P 535197

**ON-SITE SEWAGE DISPOSAL SYSTEM
 HOWARD COUNTY HEALTH DEPARTMENT
 BUREAU OF ENVIRONMENTAL HEALTH**

ADDRESS: 12821 Lime Kiln Road PROPERTY OWNER: NVR Inc.

AMENDED PERCOLATION CERTIFICATION PLAN

See As-Built Drawing
On Separate Sheet

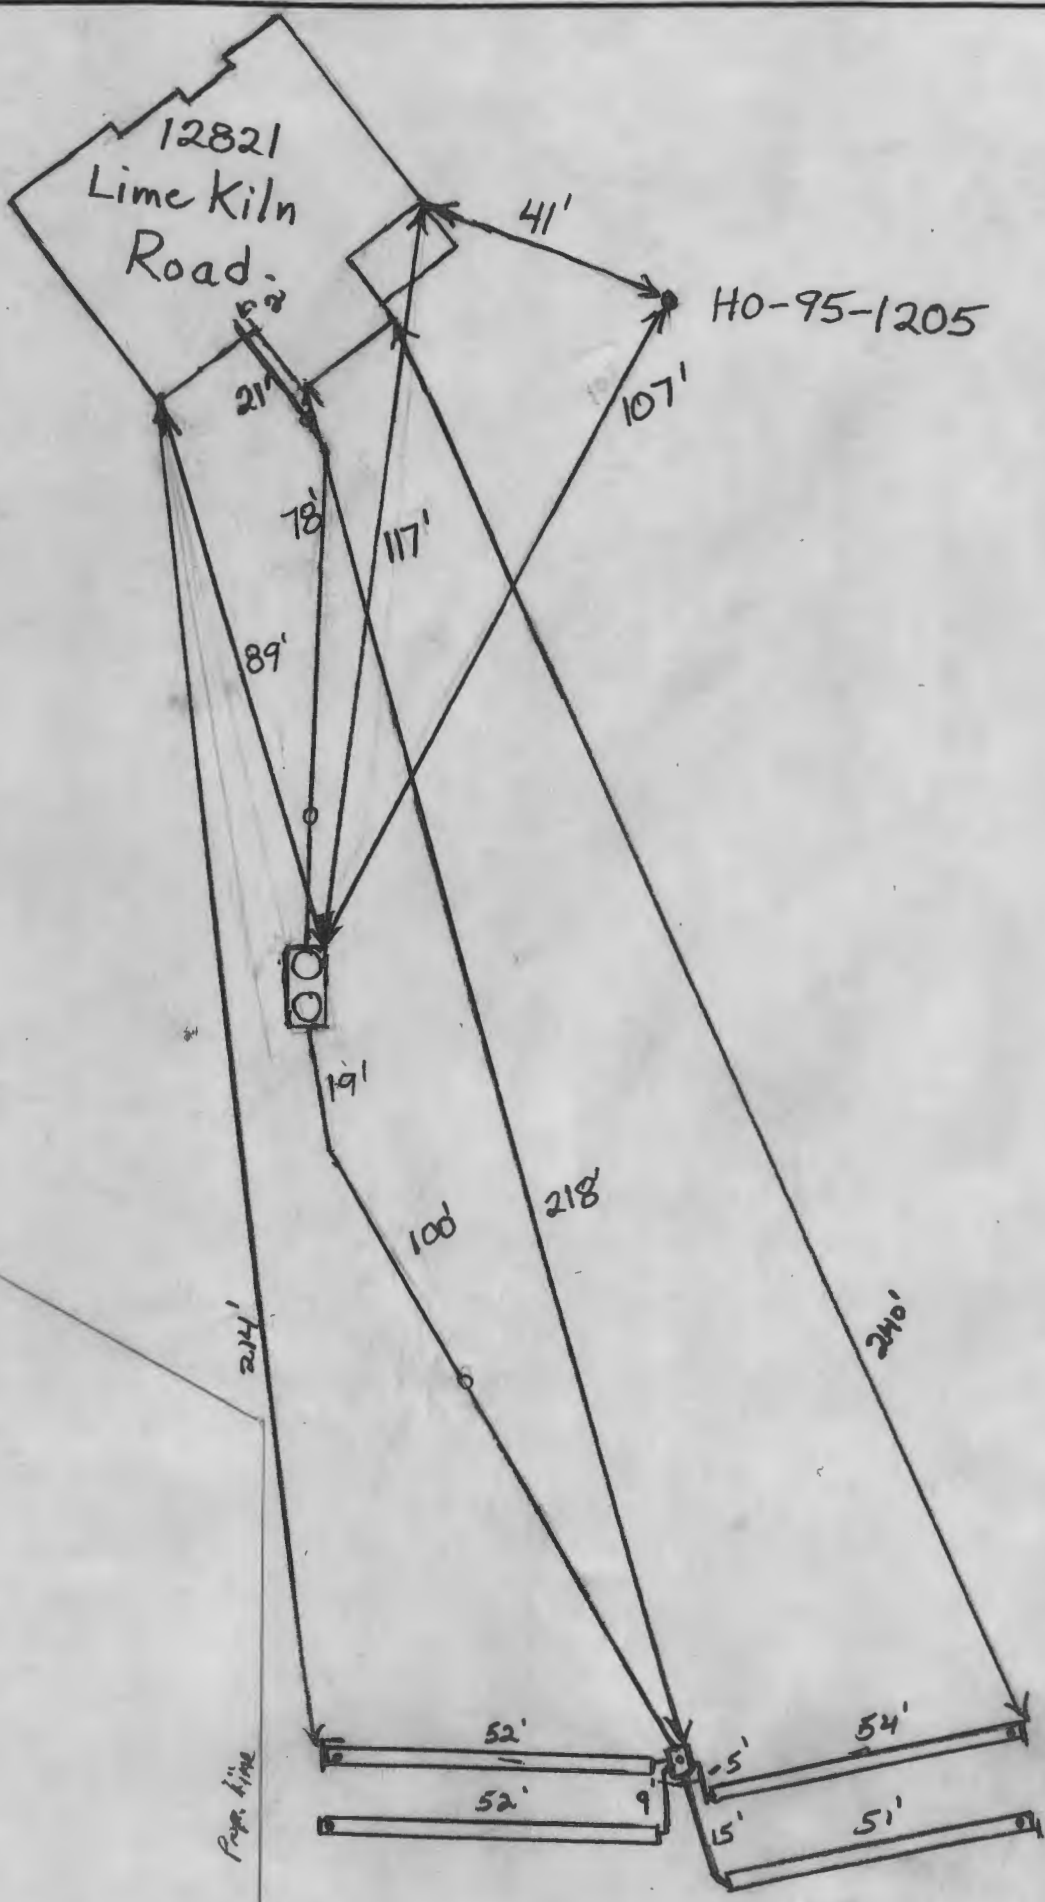
6/6/11 Took a look @ the site. Need to clear out trees and shrubs in SPA prior to giving layout. OK to set out. Keep 10' from ex well. (KB)

INSTALLATION: 6/16/11 Tank set 107' from ex well. All trenches complete and installed per layout. D box leveled. plumbing from house to tank and tank to D box not installed. Equipment back down. OK to cover trenches only! (KB)

6/17/2011 System finished. (KB)
